From: David E. Williamson  
Sent: Wednesday, December 15, 2004 11:42 AM  
To: kbowling@majortool.com  
Cc: NKHFlowen@aol.com; Phil Heitzenroeder  
Subject: FW: Drawing Vs. Model Questions

## Project response to communication from K. Bowling 12/10/04

## FLANGE INTERFACE C-C (symmetry about midplane)

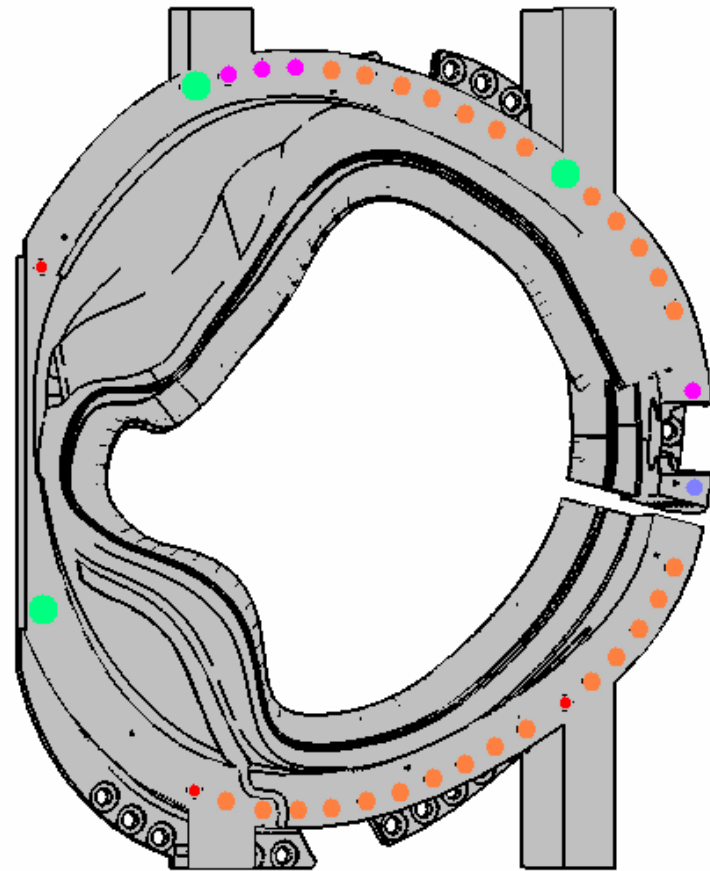
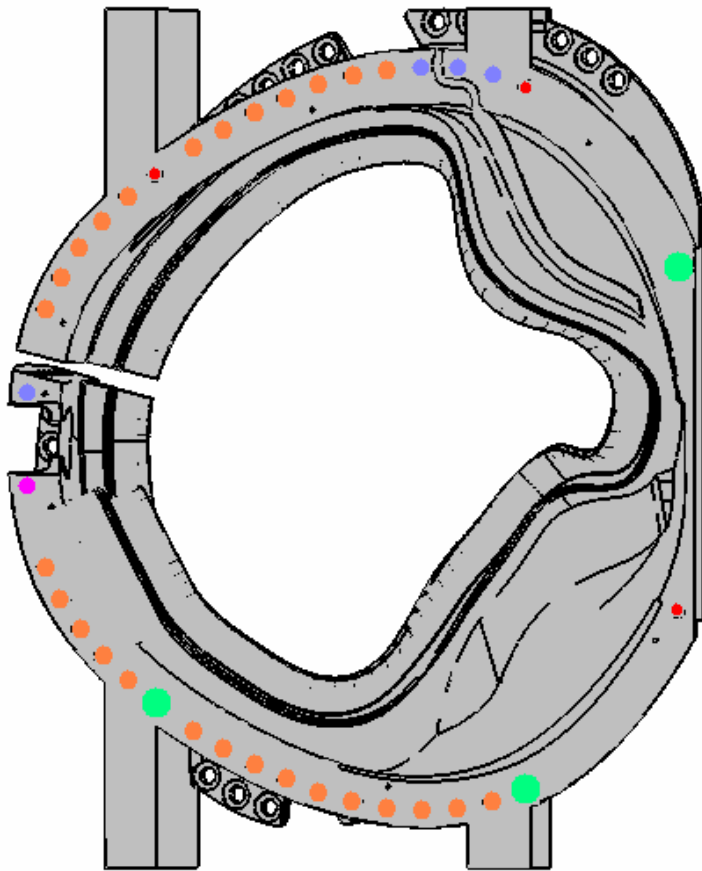
- ↔ ●  $\phi 1.875$  DRILL,  $\phi 3.25$  BACK SPOT FACE > SAME
- ↔ ●  $\phi 1.375$ -6UNC THRU >  $\phi 1.875$  DRILL,  $\phi 3.0$  BACK SPOT FACE
- ↔ ●  $\phi 3.0 \times 1$  DP CBORE,  $\phi 1.5 \times 1.5$  DP / THRU > SPHERICAL .75R

7	18	24	17	4	Ø1.875 DRILL			Sheet 4 - See Figures 6-9 for flange-to-flange hole template. Drawing notes to be clarified, models will be revised to match figures.
	"	"	"	"	Ø3.25 BACK SPOT FACE		2X type C 7.75 long	
	1	1	4	4	Ø1.875 DRILL			
	"	"	"	4 E4	Ø3.0 BACK SPOT FACE	Ø3.25	open	
	3			4	Ø.75 Thru (1.375 DP)	Ø1.50	open	
	3			4	Ø3 x 1 DP CBORE			
	6	10	20	4	Ø.201 x .5 DP			
		"	"	"	.250-20 TAP	no tap on A	open	
	"	"	"	"	Ø.507 x 82 Deg Chamfer			
			6	4	Ø1.125 DRILL			
8			"	"	Ø3.38 BACK SPOT FACE	Ø2.38	open	Sheet 5 - See Figures 6-9 for flange-to-flange hole template. Drawing notes to be clarified, models will be revised to match figures.
	1	3	4	5	Ø1.875 DRILL	check C5 Sec ZZ		
	"	"	"	5 D7	Ø3.0 BACK SPOT FACE	Ø3.25	open	
	3	3	2	5	Ø3 x 1 DP CBORE			
	3		2	5	Ø.75 x 2.33-B/ 2.0-C	Ø1.50	open	
			3	5	Ø1.5 X 1 DP			
	3			5	Ø1.5 X 1.33 DP			
				5	Ø1.125 DRILL			
			"	"	Ø3.38 BACK SPOT FACE	Ø2.38	open	
		7			Ø1.500 DRILL	Ø1.625	open
